Addendum No. 03

SUBJECT: Willamette River: Stormwater Source Control Improvements Project
Lower Columbia River, Northeast Portland, Stadium Freeway
Multnomah
Grading, Drainage, Paving, Signing, Illumination, and Roadside Development
(Bids Closing April 30, 2026)

1. Plan sheets BA03, BA04, BA08, C201, C581, ES01, FA201, FB201, GA201, HA201, HA401A, HB202, PA201, S02, TA201 are replaced with revised plan sheets BA03, BA04, BA08, C201, C581, ES01, FA201, FB201, GA201, HA201, HA401A, HB202, PA201, S02, TA201.

GEOTECHNICAL DATA	SHEET NO. GA201
--------------------------	--------------------

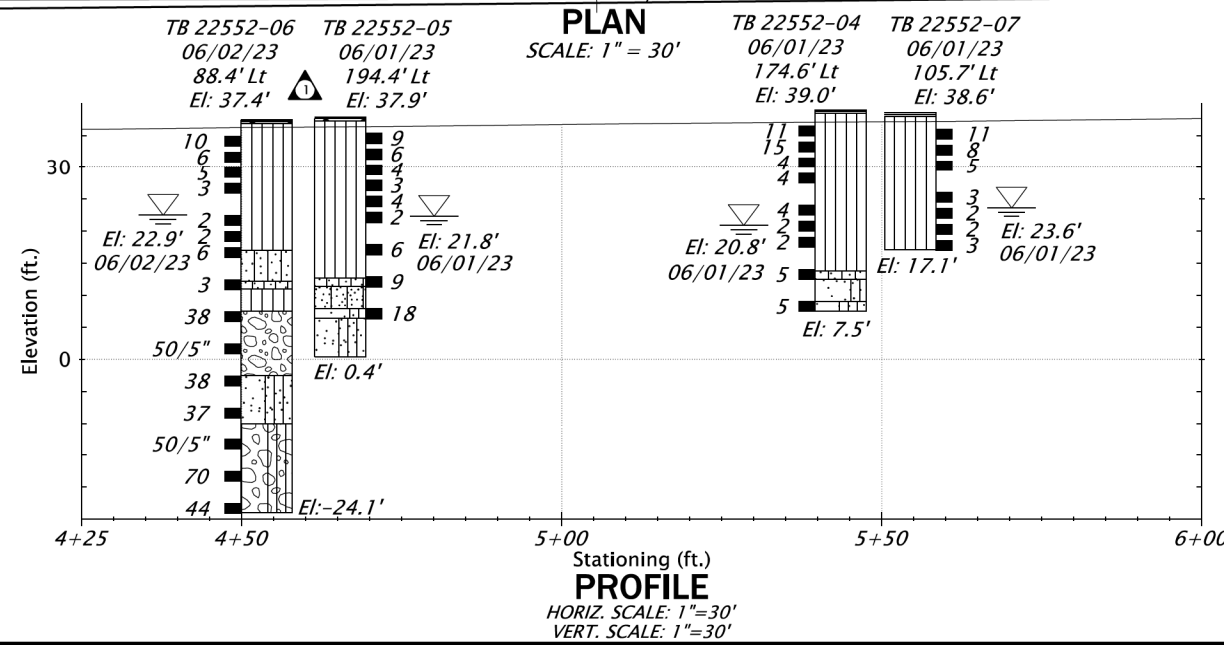
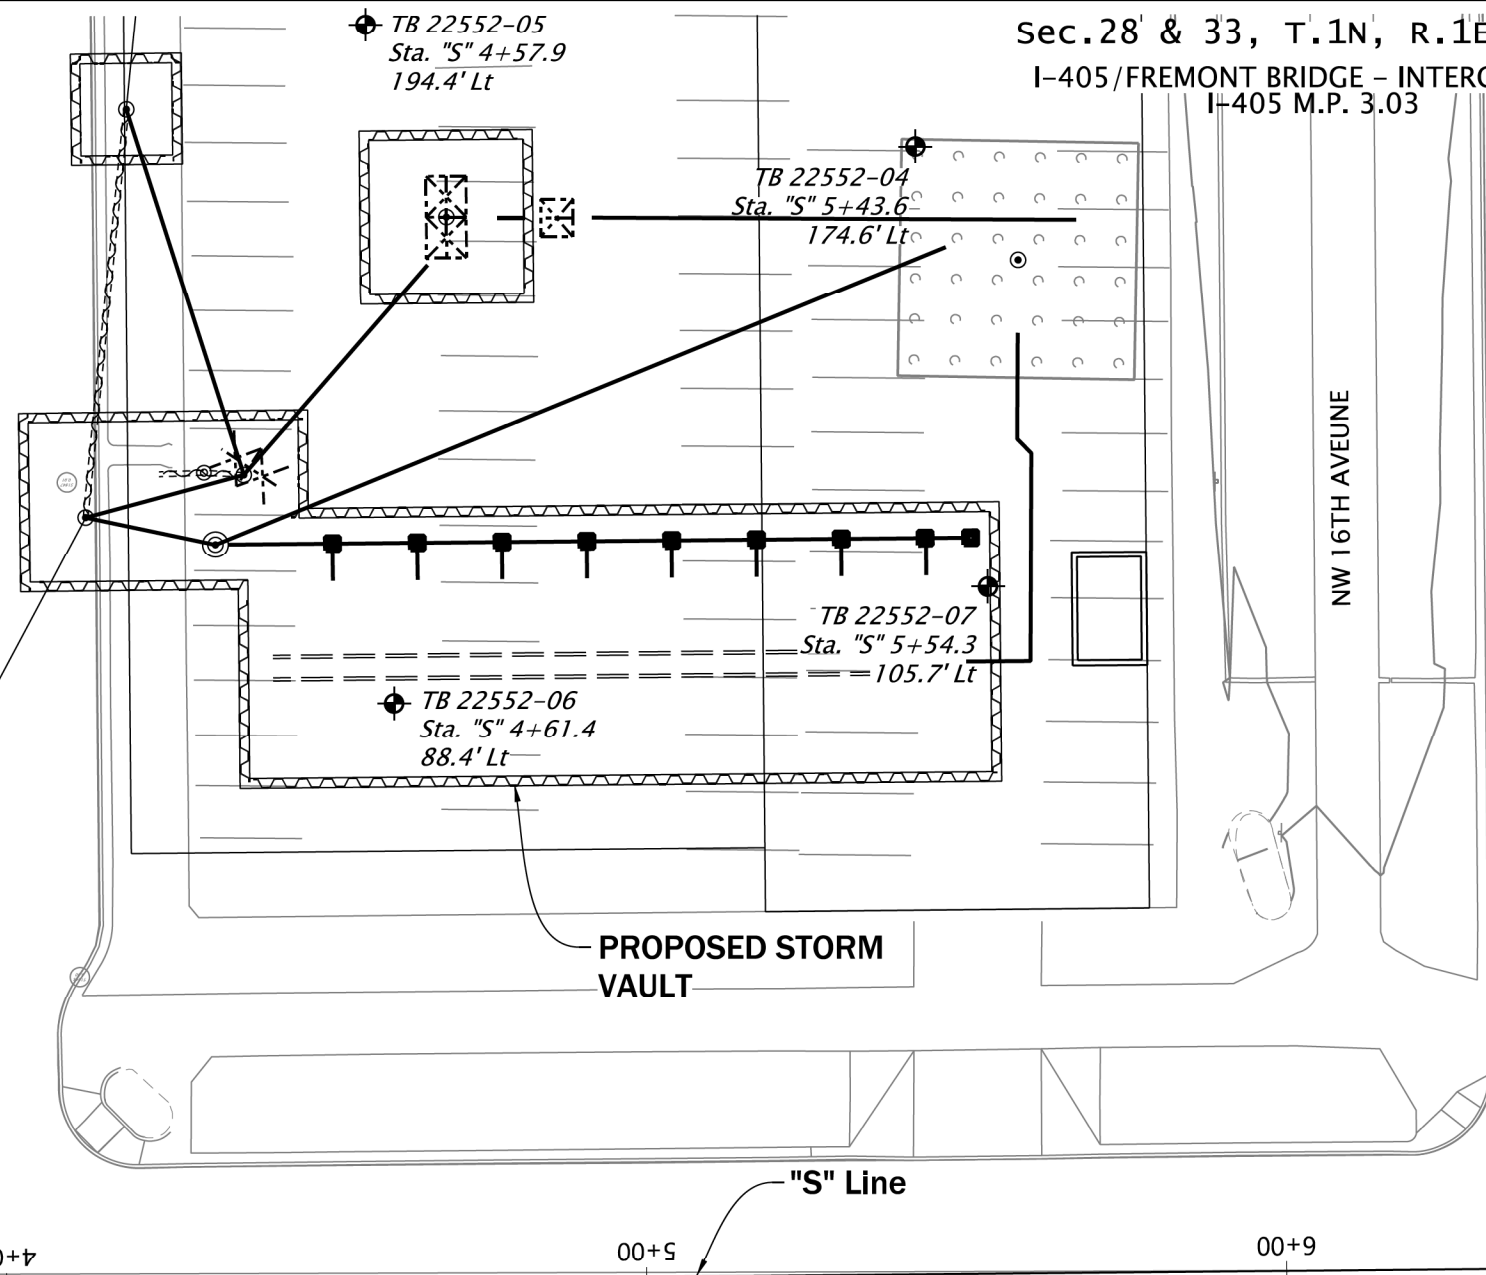
No.	DATE	REVISIONS	BY
1	04-21-26	Revised Boring log numbers	R.A.

SHEET NO.
HA201

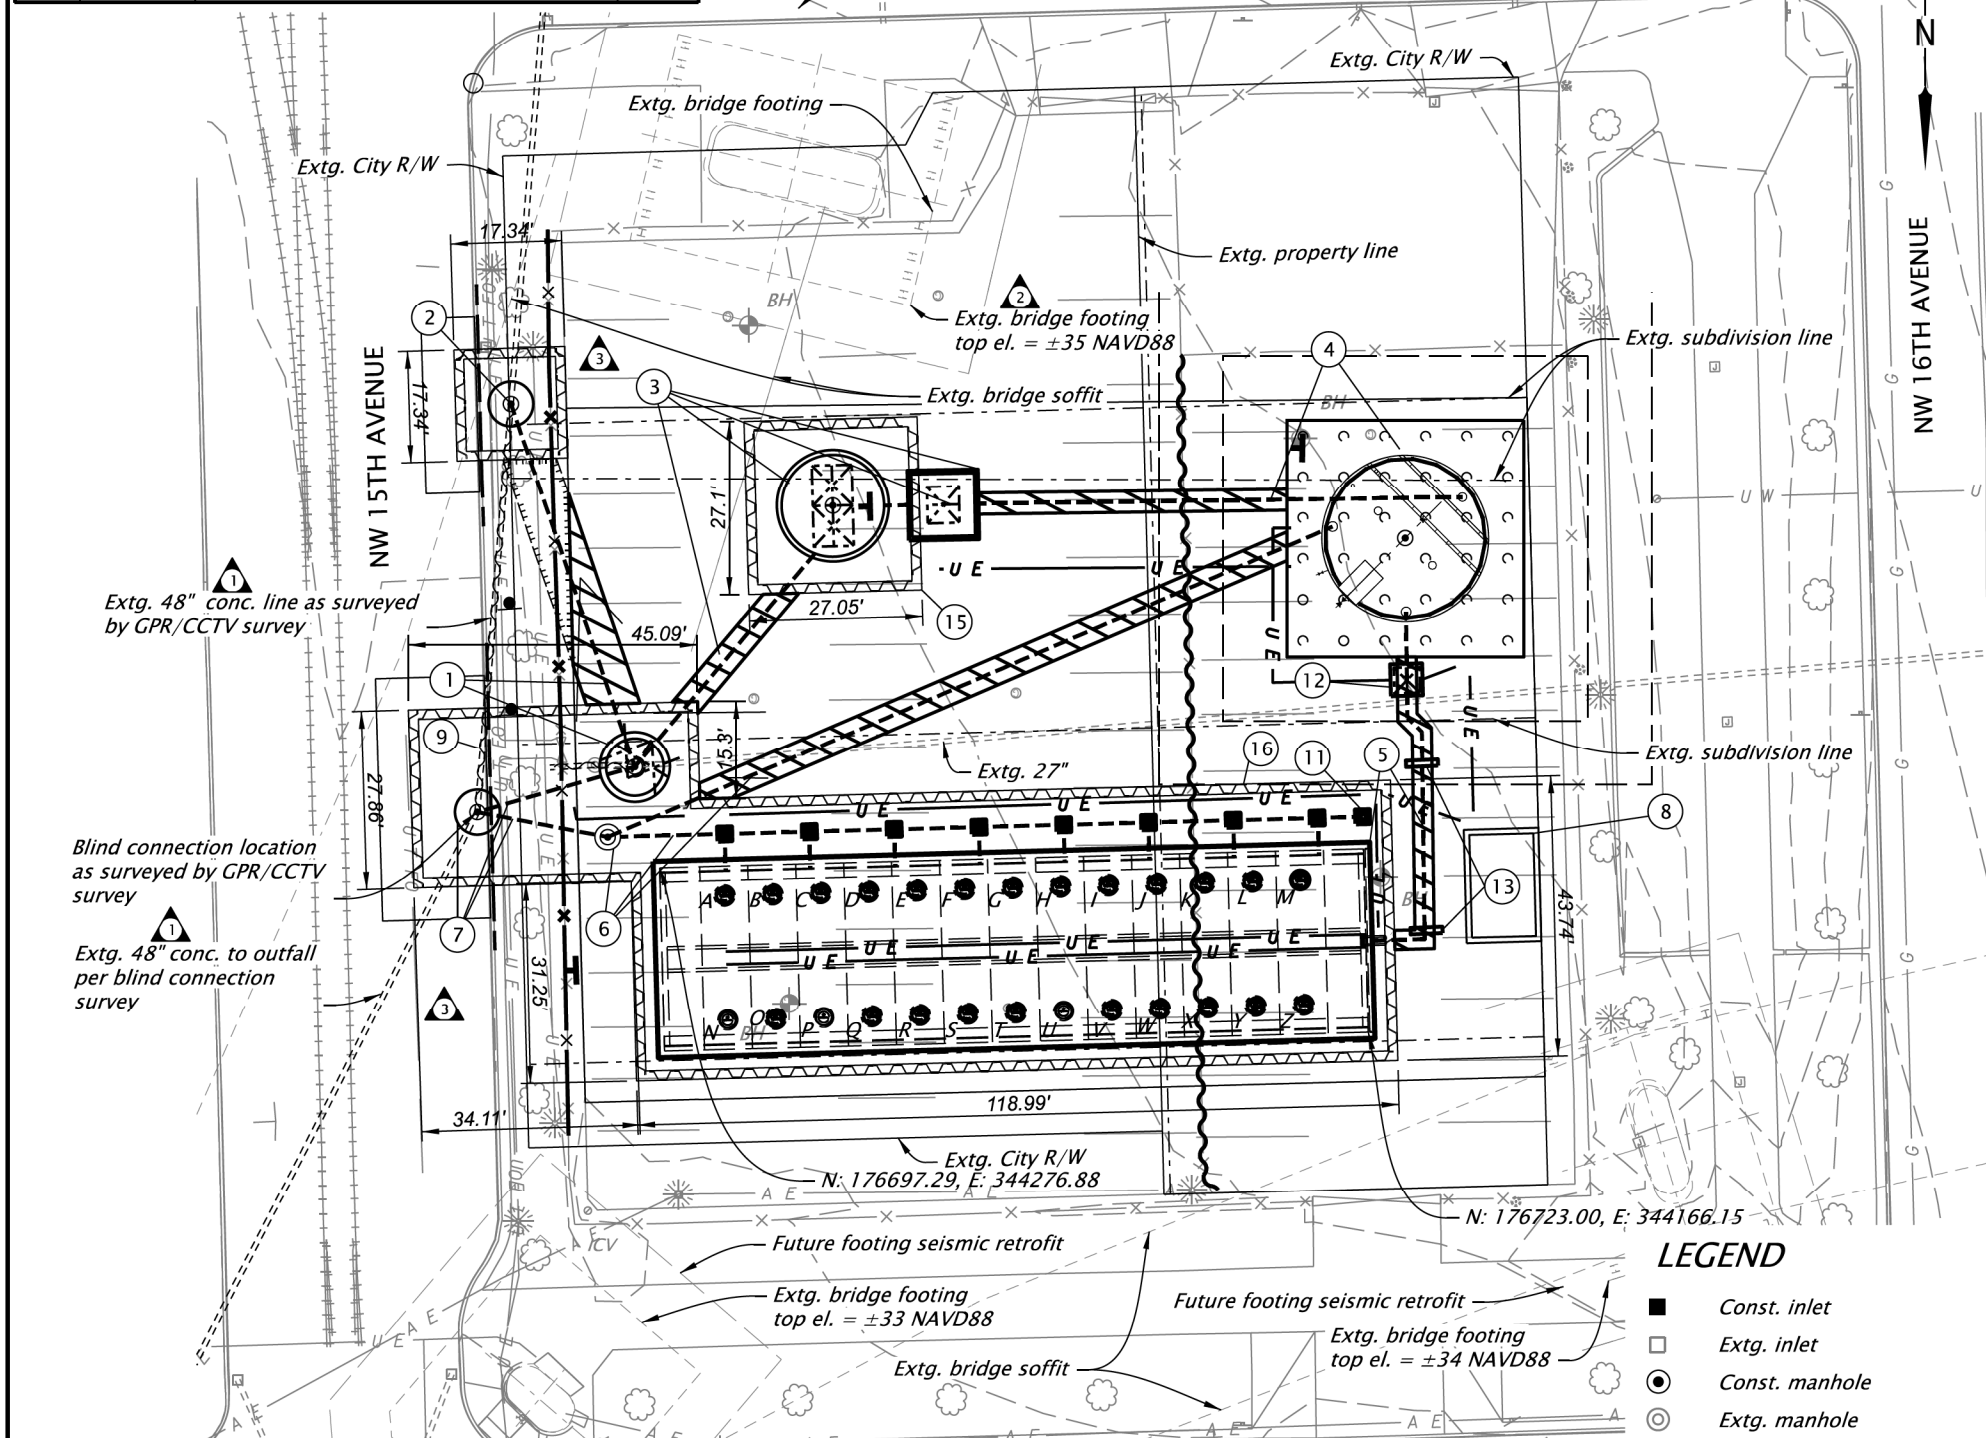
No.	DATE	REVISIONS	BY
1	04-15-26	Added material to exist. 48" pipe callout	J.G.H.
2	04-15-26	Added approx. bridge footing el. callout	J.G.H.
3	04-16-26	Removed 42" extg. storm sewer pipe	J.G.H.

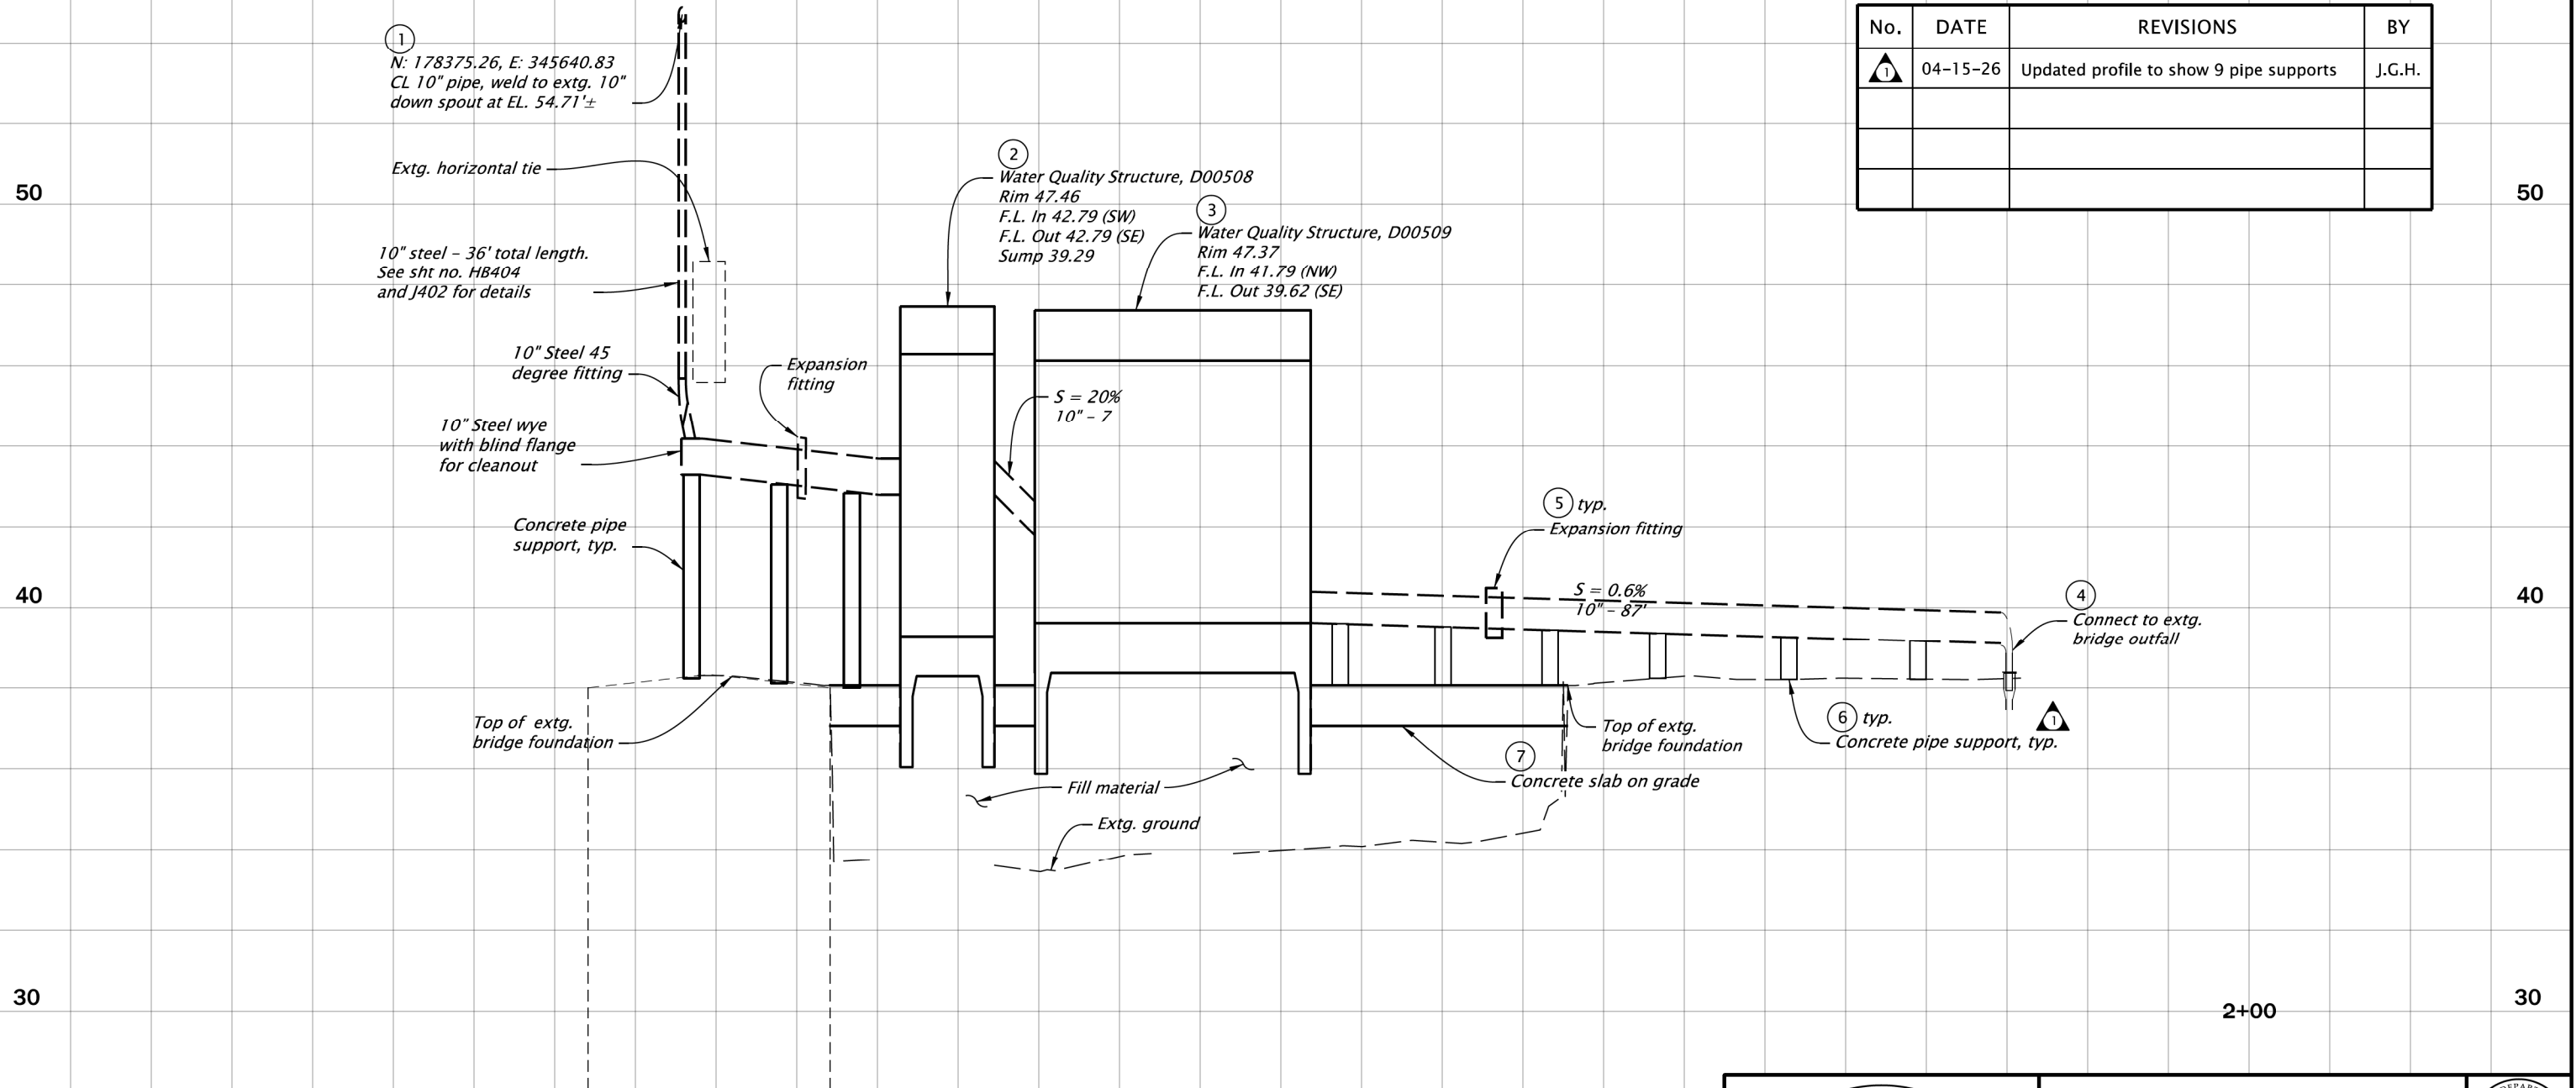
No.	DATE	REVISIONS	BY
1	04-15-26	Updated profile to show 9 pipe supports	J.G.H.
